**SITE PLAN REVIEW
PLANNER'S PUBLIC HEARING REPORT
Rocky Springs RV Park Site Plan Review
17094 Martin Pedro Road, Siloam Springs AR 72761**

RE: Rocky Springs RV Ranch - Comment Response Letter

ROCKY SPRINGS RV RANCH

WATER TREATMENT DETAIL N.T.S.

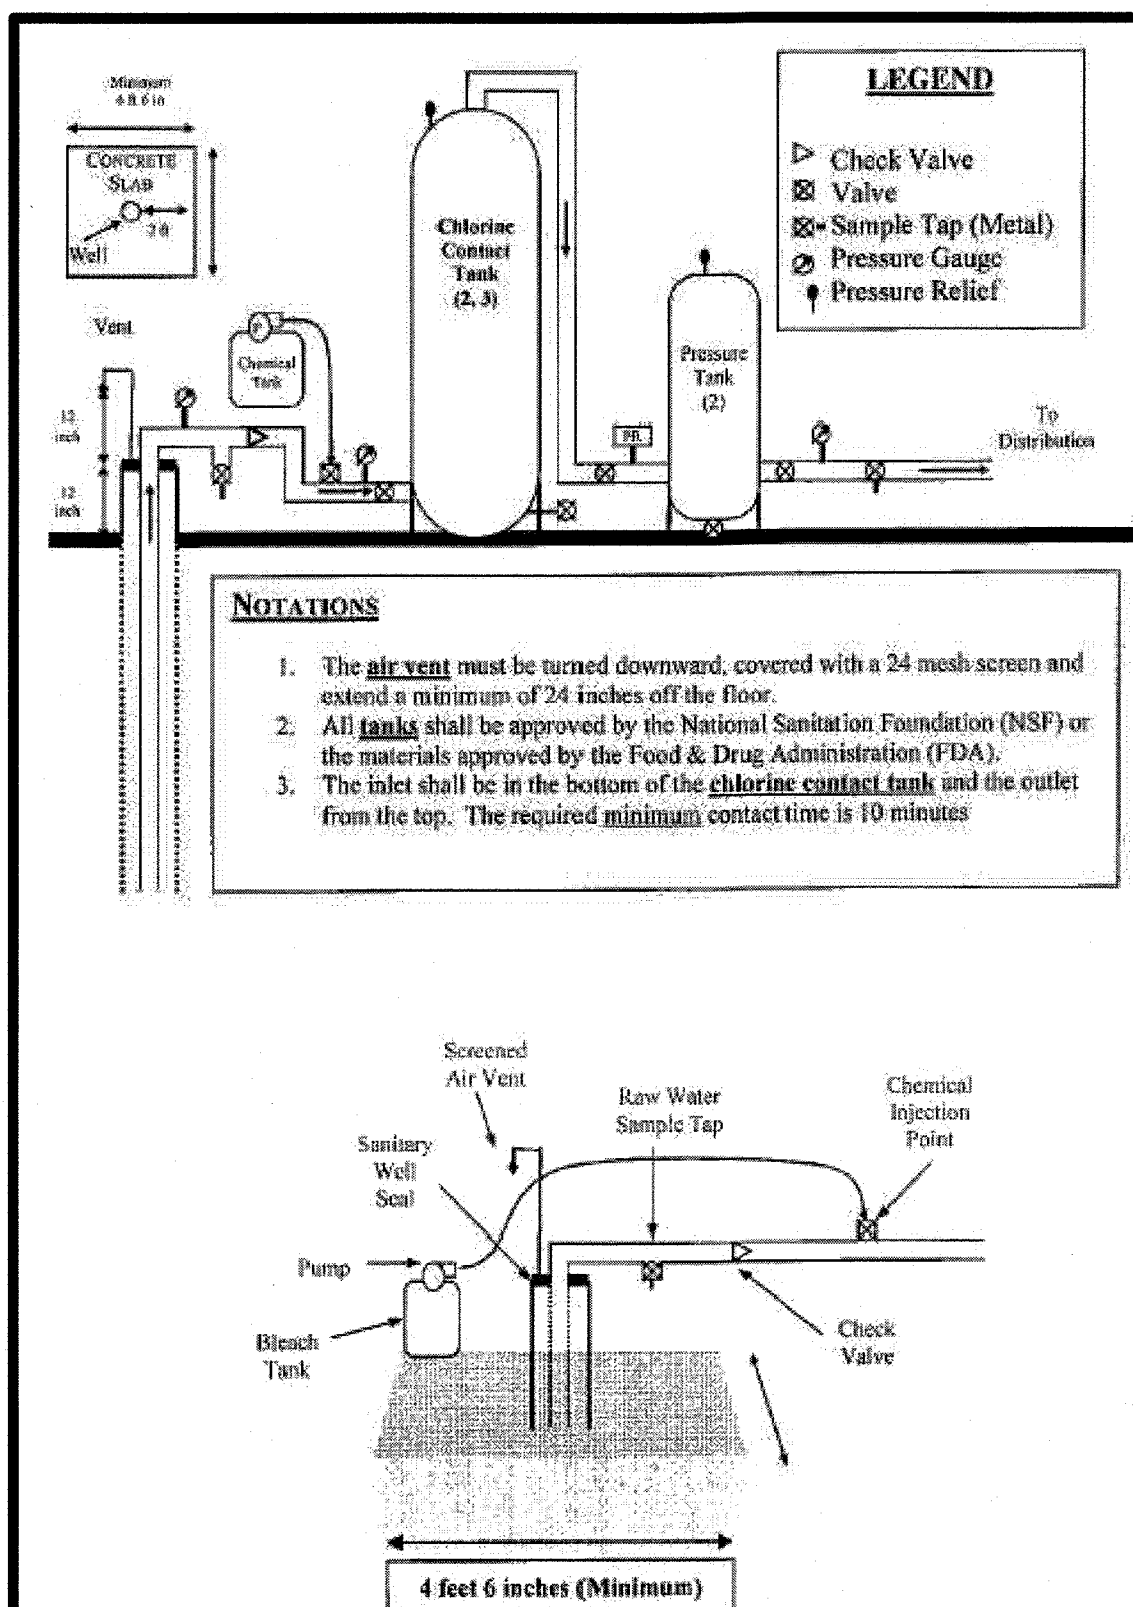
1. Well head construction details, disinfection system components, retention tank (if used), pressure tank(s) and a rough plumbing schematic are not shown. We need to review this portion of the treatment system in order to complete the plan review. Sample diagrams and instructions are in the "Guidelines" document.
2. The well is required to have 100' protected radius. Please adjust the proposed well location so that the existing pond is at least 100' away. (ref. *Rules and Regulations Pertaining to Semi-Public Water Systems* by the Arkansas Board of Health, Section VI, D.) (I know the well recommendation had GPS coordinates. Those are rough coordinates (actually, the spring coordinates that you gave me) that I gave to the geologist to locate the property. Sorry if that caused confusion.)
